**Feedback regarding the May 15th DRB meeting...**

Re: Hill and Locust Proposed Development

To the Design Review Board, regarding 4-D-24-DT:

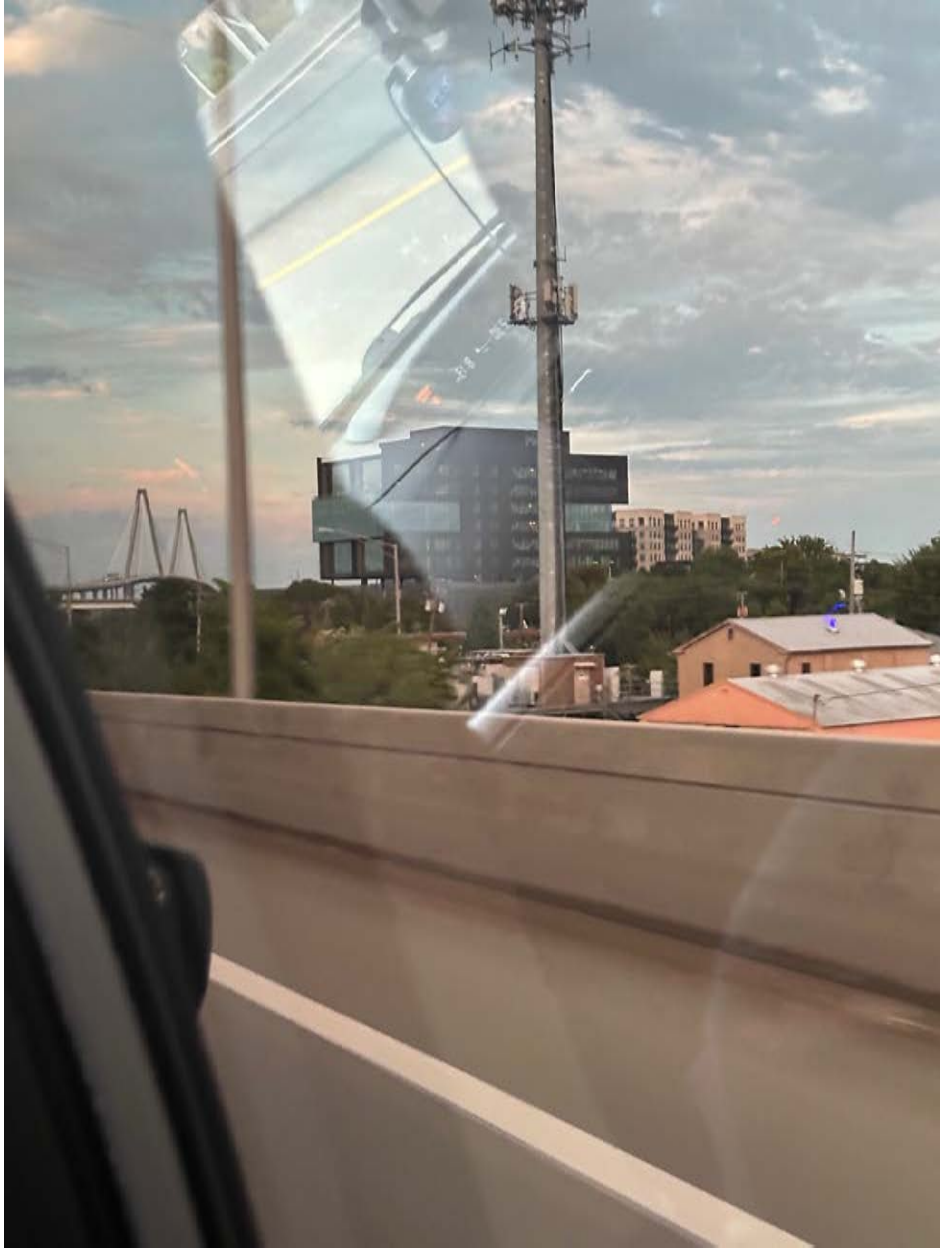
In closing, I've attached a photo of an apartment complex in Charleston that blocks the harbor, similar in design to the proposed building, similar in setting, and similar in scale. If you go to Woodfield development website, you may find that it is remarkably similar to Morrison Yard. I encourage you to do your own research. A final product and a render are two different things.

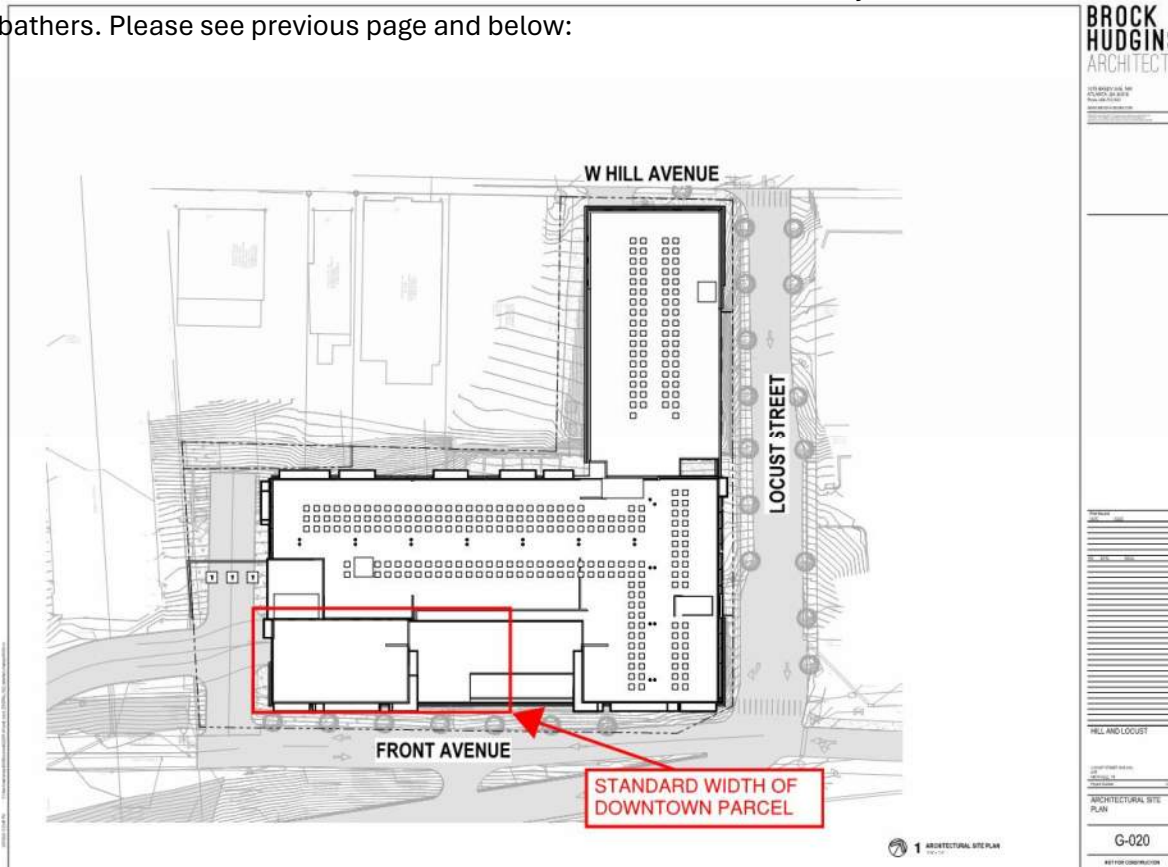
1. Mr. Thurman noticed that the renderings presented at the April 17th board meeting seemed “off.” He is correct. Below: Original rendering provided by Applicant to DRB for April 17th review. Bottom: Corrected rendering bringing the Waterfront facing façade to Front Avenue as shown in applicants site plan.

The building footprint in the rendering does not match the site plan footprint as its waterfront facing façade is pulled back, by a width of a standard downtown parcel, to the gravel thoroughfare on the site yet to be purchased by the applicant (below). The applicant's provided rendering minimizes the building's impact and size, removing thousands of square feet of building. It also means that half of an arch of the Henley Street bridge will be obscured. Residents of the block have made the developers and Architect aware of this – they insisted that the gravel roadway through the property they are looking to purchase is Front Avenue. We live here, we know where Front Avenue is located. In the revised rendering, by the residents of the block, we can see the true impact of the proposal on the site, its surroundings, the waterfront, pedestrian safety, the overall aesthetic of Downtown Knoxville, and how the south entrance to downtown will be obliterated by a billboard of concrete, cars, and sunbathers. Please see previous page and below:

Above: In applicant supplied rendering, the waterfront façade plane is brought back to the gravel thoroughfare on the yet to be attained lots. Their site plan shows the waterfront façade plane being nearly on top of Front Avenue. Their rendering is inconsistent with the site plan and misrepresentative of applicant's intentions.

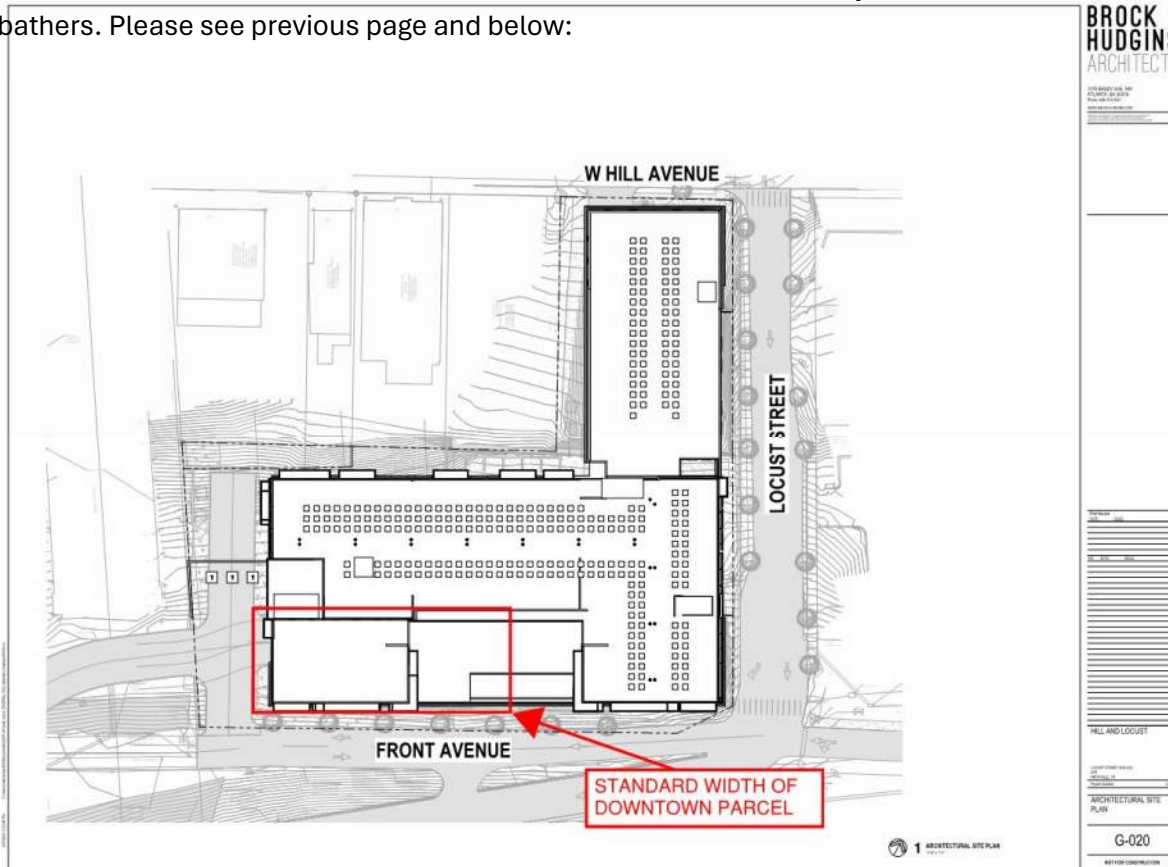
1. Mr. Thurman noticed that the renderings presented at the April 17th board meeting seemed “off.” He is correct. Below: Original rendering provided by Applicant to DRB for April 17th review. Bottom: Corrected rendering bringing the Waterfront facing façade to Front Avenue as shown in applicants site plan.

The building footprint in the rendering does not match the site plan footprint as its waterfront facing façade is pulled back, by a width of a standard downtown parcel, to the gravel thoroughfare on the site yet to be purchased by the applicant (below). The applicant's provided rendering minimizes the building's impact and size, removing thousands of square feet of building. It also means that half of an arch of the Henley Street bridge will be obscured. Residents of the block have made the developers and Architect aware of this – they insisted that the gravel roadway through the property they are looking to purchase is Front Avenue. We live here, we know where Front Avenue is located. In the revised rendering, by the residents of the block, we can see the true impact of the proposal on the site, its surroundings, the waterfront, pedestrian safety, the overall aesthetic of Downtown Knoxville, and how the south entrance to downtown will be obliterated by a billboard of concrete, cars, and sunbathers. Please see previous page and below:

Above: In applicant supplied rendering, the waterfront façade plane is brought back to the gravel thoroughfare on the yet to be attained lots. Their site plan shows the waterfront façade plane being nearly on top of Front Avenue. Their rendering is inconsistent with the site plan and misrepresentative of applicant's intentions.
